Department of Energy  
Washington, D.C. 20545

Docket No. 50-537  
HQ:S:82:047

RESPONSES TO REQUEST FOR ADDITIONAL INFORMATION

Reference: Letter, P. S. Check to J. R. Longenecker, "CRBRP Request for Additional Information," dated February 26, March 11, and April 9, 1982

Figure 3.9-4 Reactor Internals Flow Induced Vibration Program

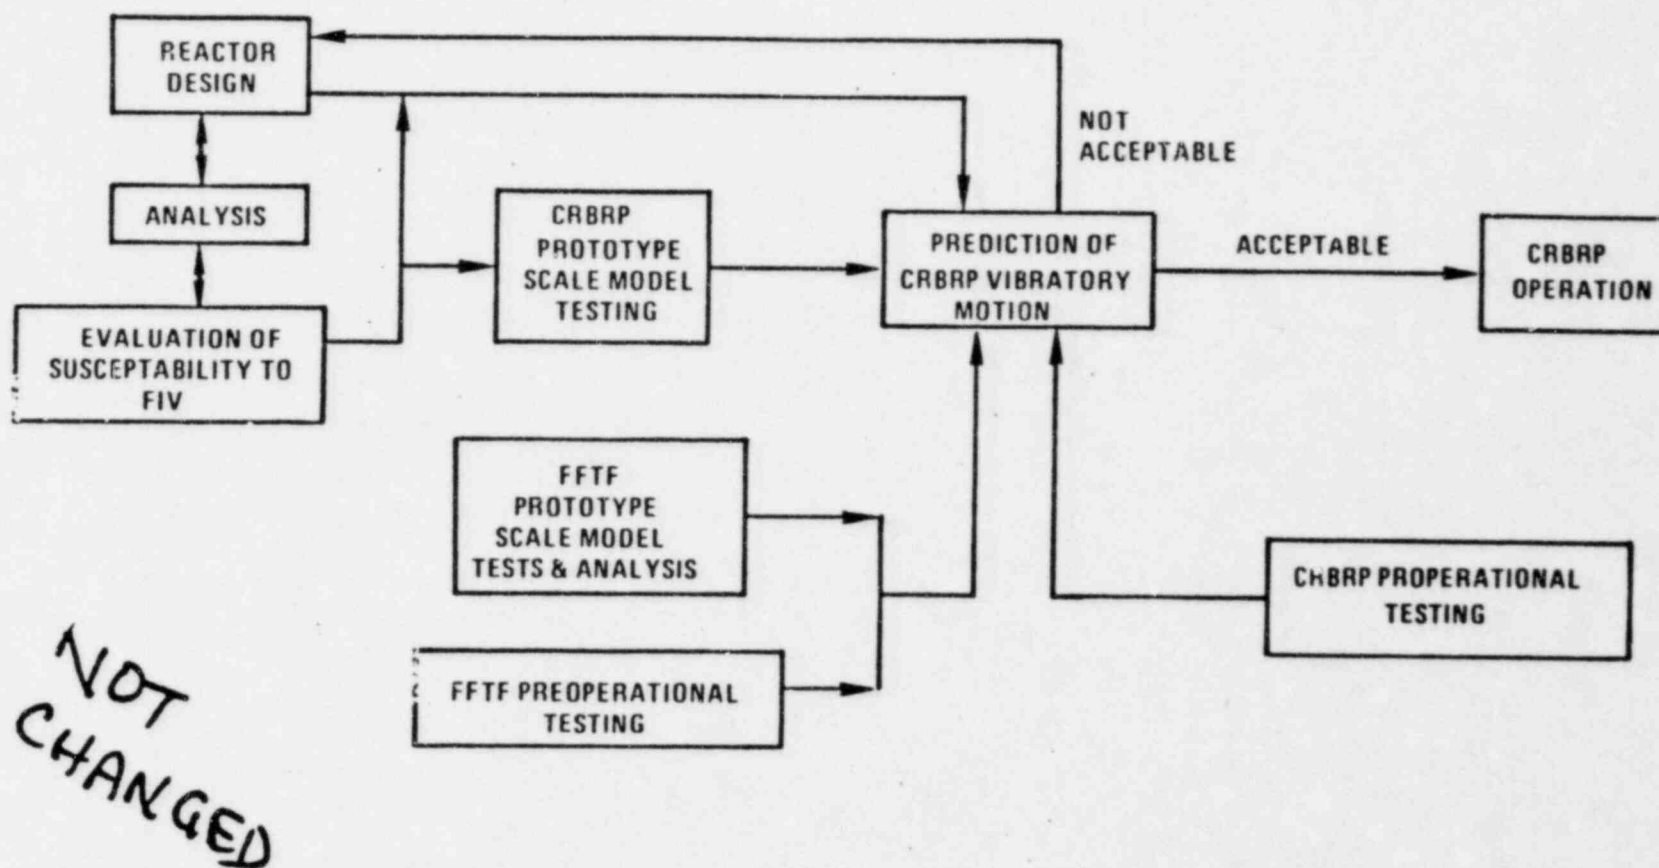
Describe the CRBR prototype scale model testing program and its correlation with the CRBR preoperational vibration testing program for assessing CRBR Internals vibration motion. In addition, describe the acceptance criteria for Internals vibration tests.

A comprehensive vibration assessment program to assure that excessive flow induced vibratory motion of reactor Internals does not exist, is part of the CRBRP program. The program, schematically illustrated in Figure 3.9-4, assures the structural integrity of reactor Internals. The program accomplishes this objective by means of the following key actions:

FIGURE 3.8-9 TYPICAL SECTION THROUGH REACTOR VESSEL LEDGE SUPPORT  
Sheet 1 of 2

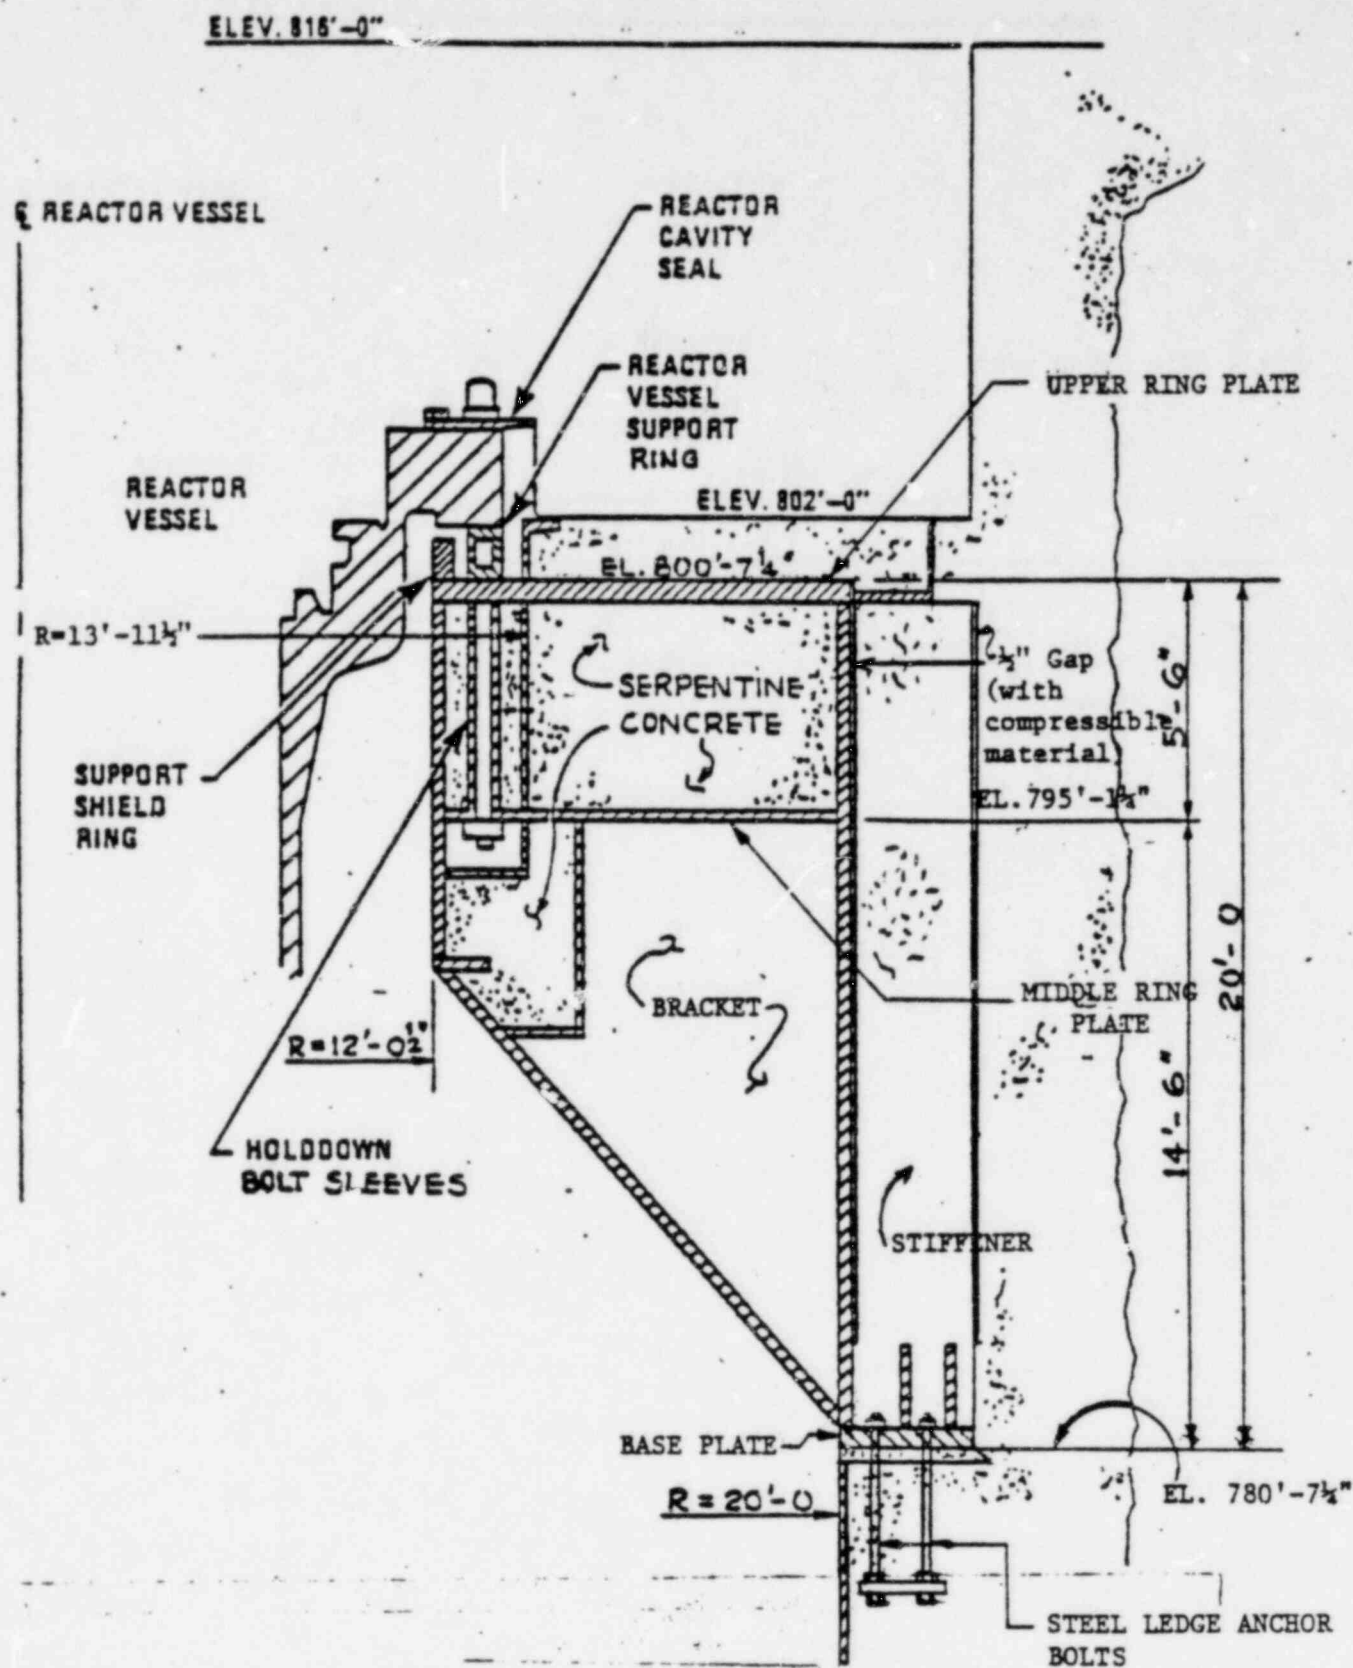
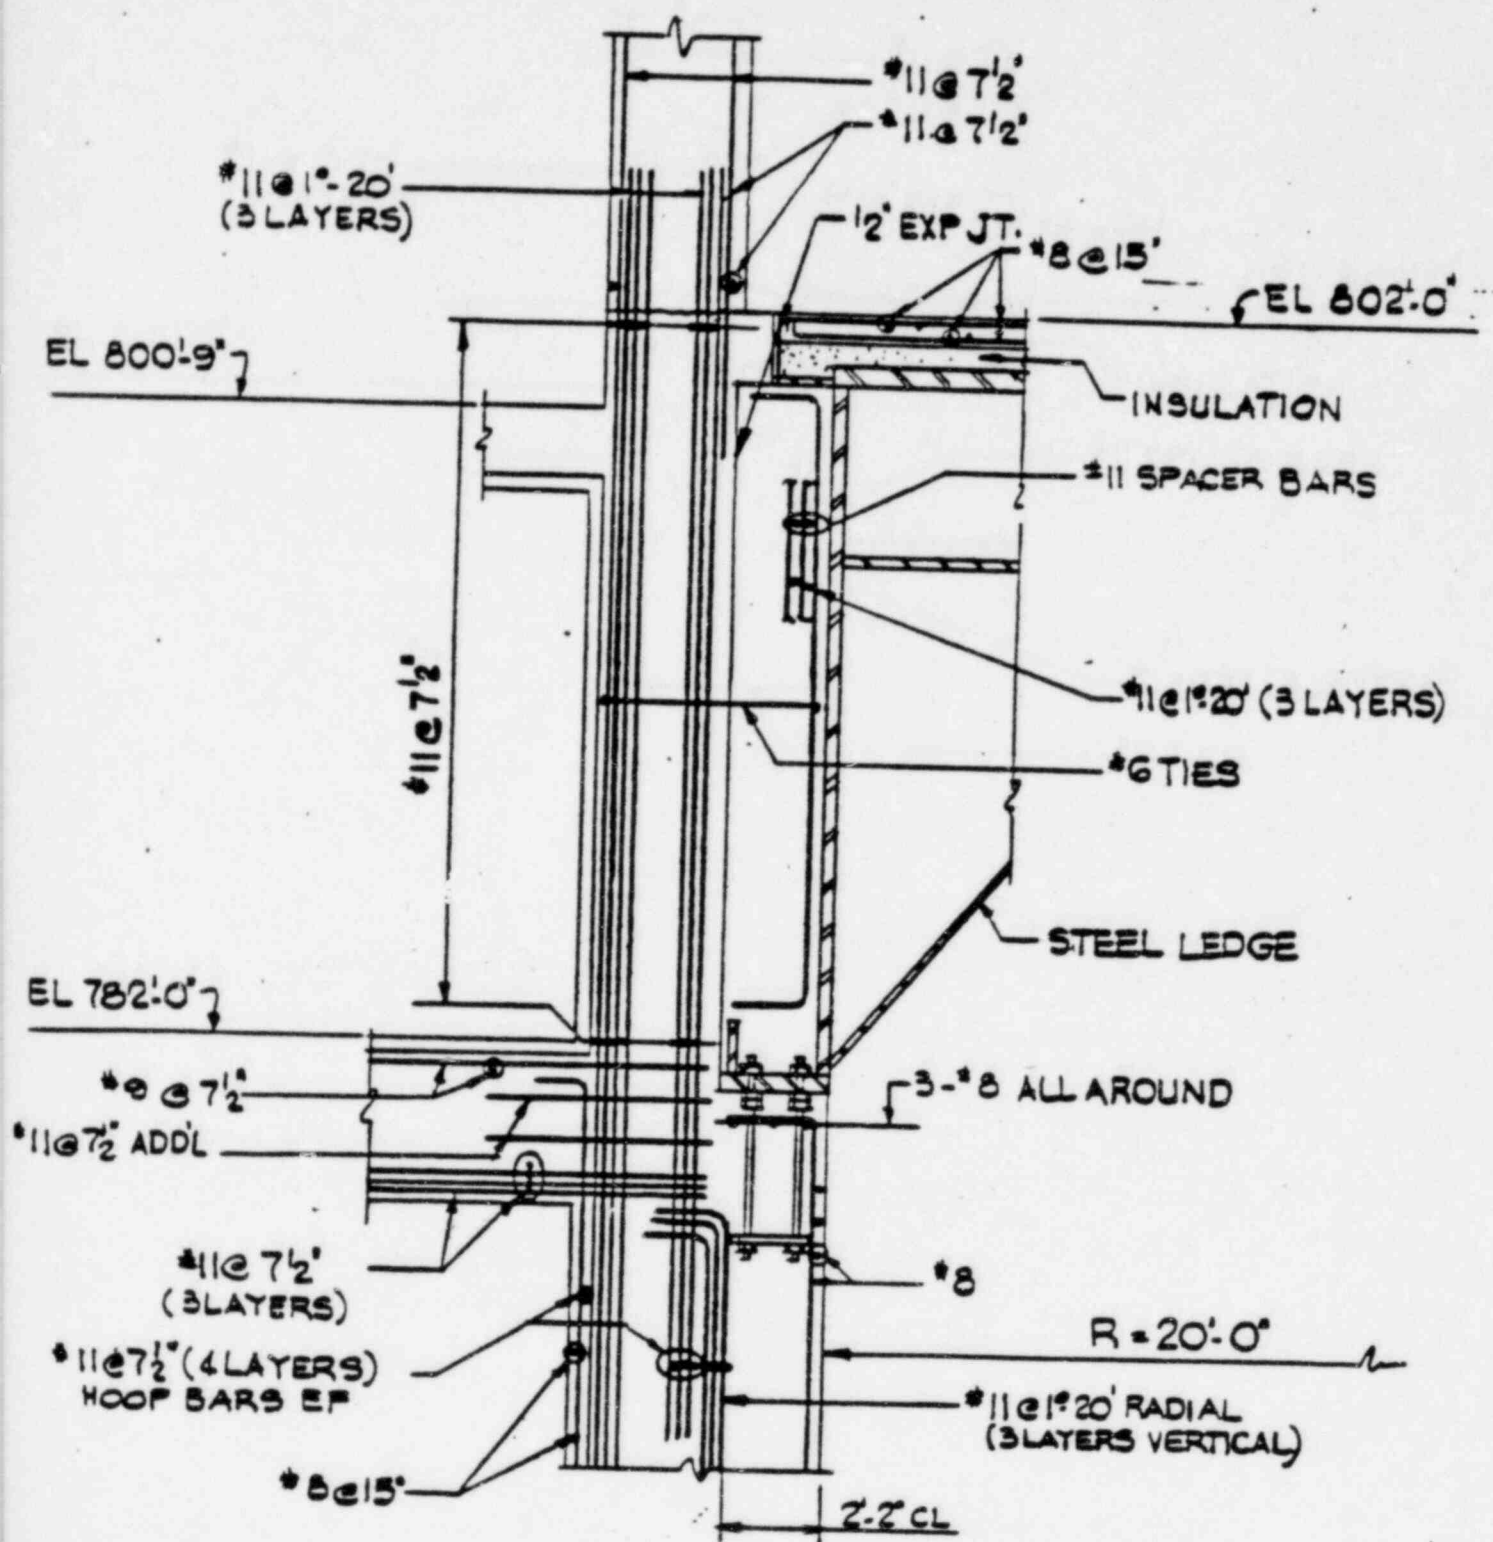
- a) Figure 3.8-9 should label elements discussed in the text (3.8.3.1.1).  
Details of concrete reinforcing are needed to evaluate the support ledge.

Revised PSAR Figure 3.8-9 labels elements discussed in the text (3.8.3.1.1). An additional sketch, showing the reinforcing bars in the reactor cavity at the ledge area has been included.

Figure QCS 421.4-2

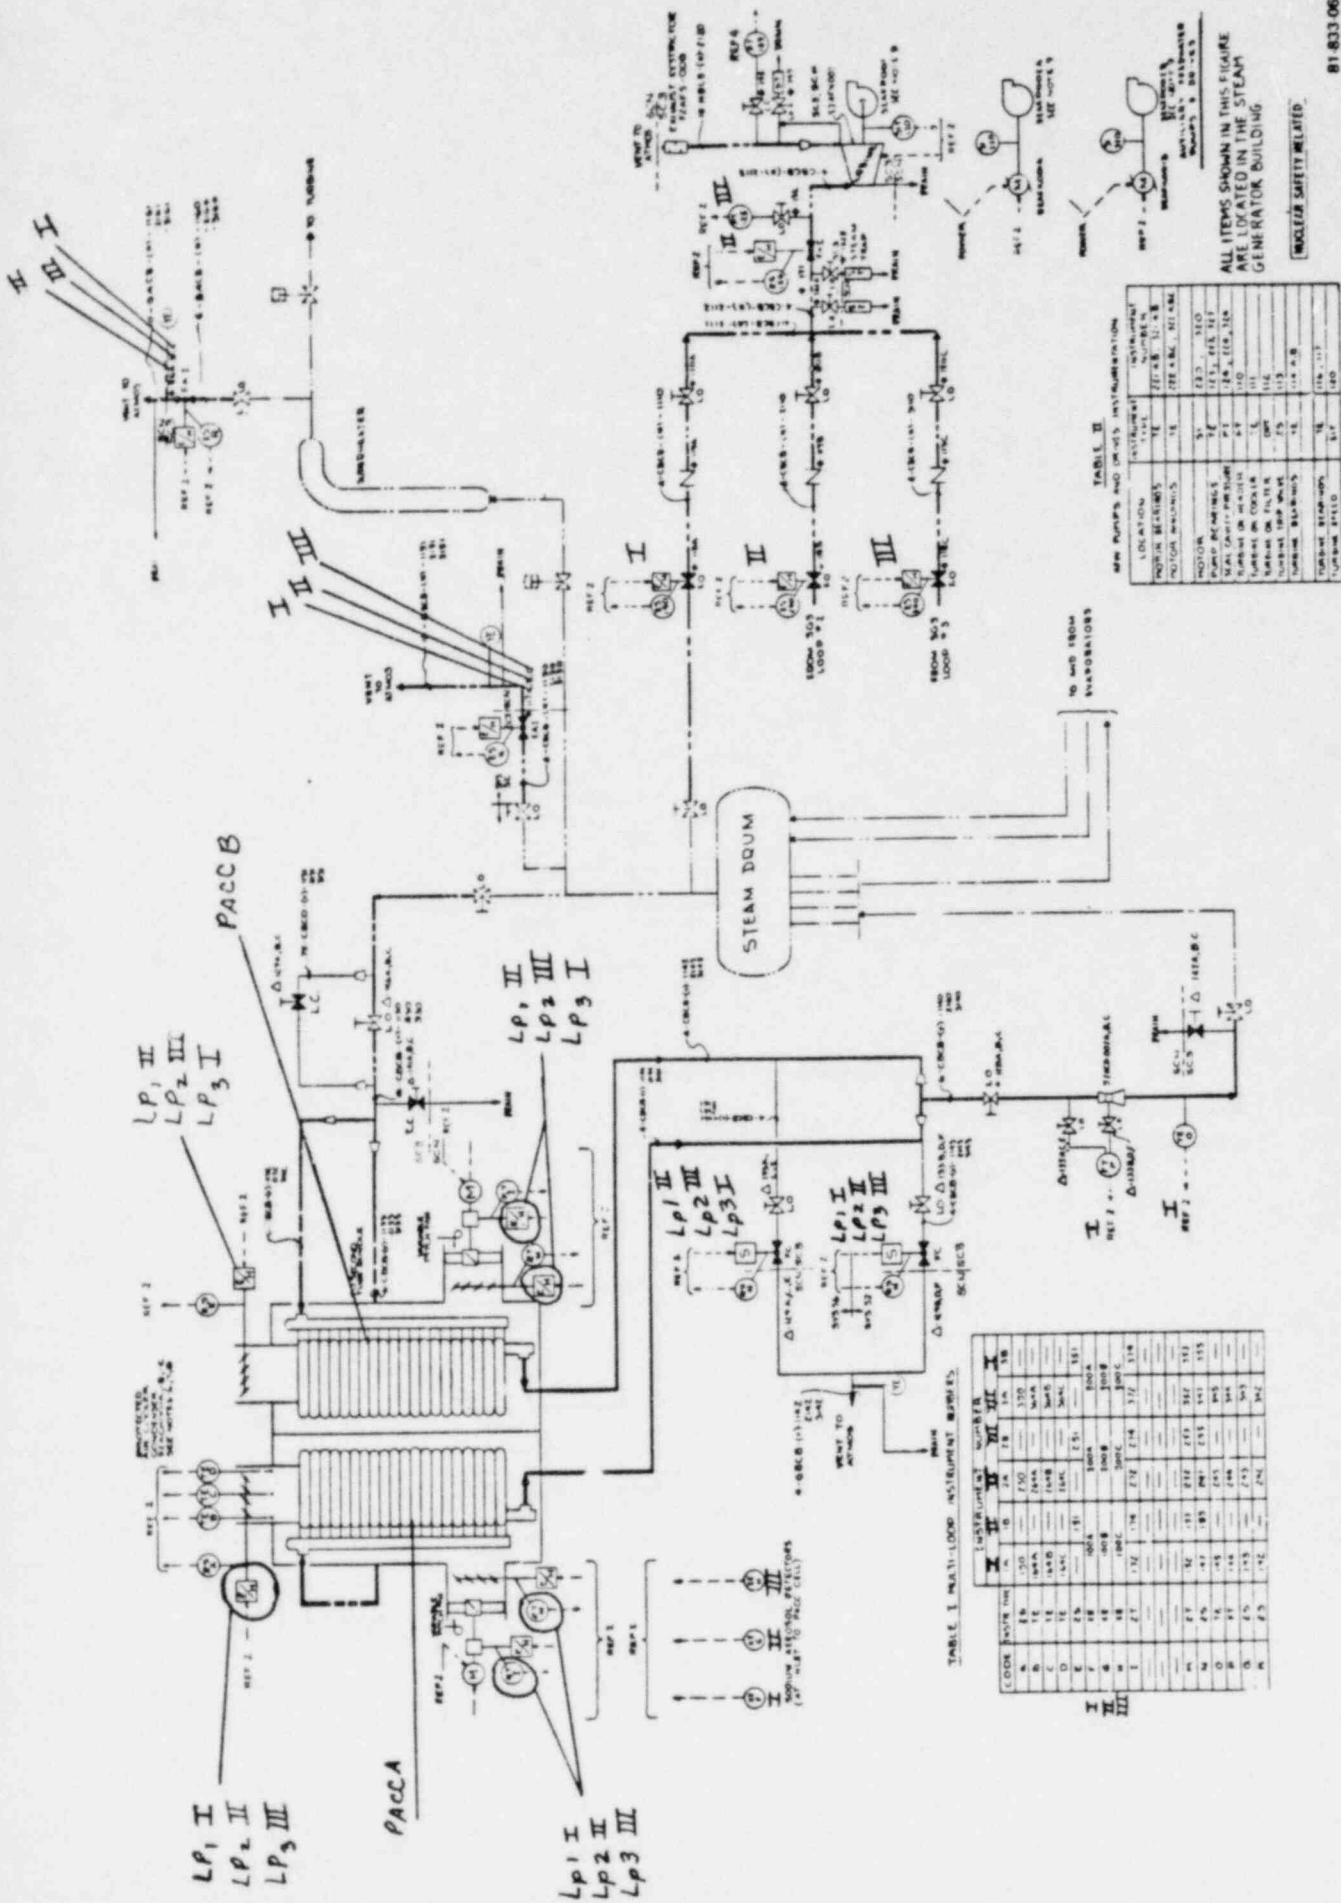
Question QCS 421.4

Figures 5.1-5 and 5.1-5a of the PSAR (attached) have been marked up (Figures QCS 421.4-1, 2) to show the power division assignments for all valves and safety grade instrumentation. The controls for the devices are not shown, however, the power assignment is the same as that of the valves, louvers, and fan blade pitch control being actuated. The normal position and failure position of the valves are shown in Figures 5.1-5 and 5.1-5a.

As shown in Figure 5.1-5 there are six isolation valves, two in parallel to each steam drum. One valve supplies water from the electric driven pumps, the other, from the turbine drive pump. Each capable of supplying 100 percent water flow to the steam drum. These two valves are supplied power from separate Class 1E power divisions. The failure of one valve to open on demand would not result in the loss of water to a steam drum.

Failures such as shorts, grounds, power supply opens, etc. which result in the loss of power and thus opening the valves will not be discussed. Even if these occur during reactor power operation they have no effect on power operation or the ability of SG4HRS to function when called upon.

Each isolation valve is supplied from a regulated 120 VAC power supply and is designed to operate with the over voltage transients identified for the power supply.
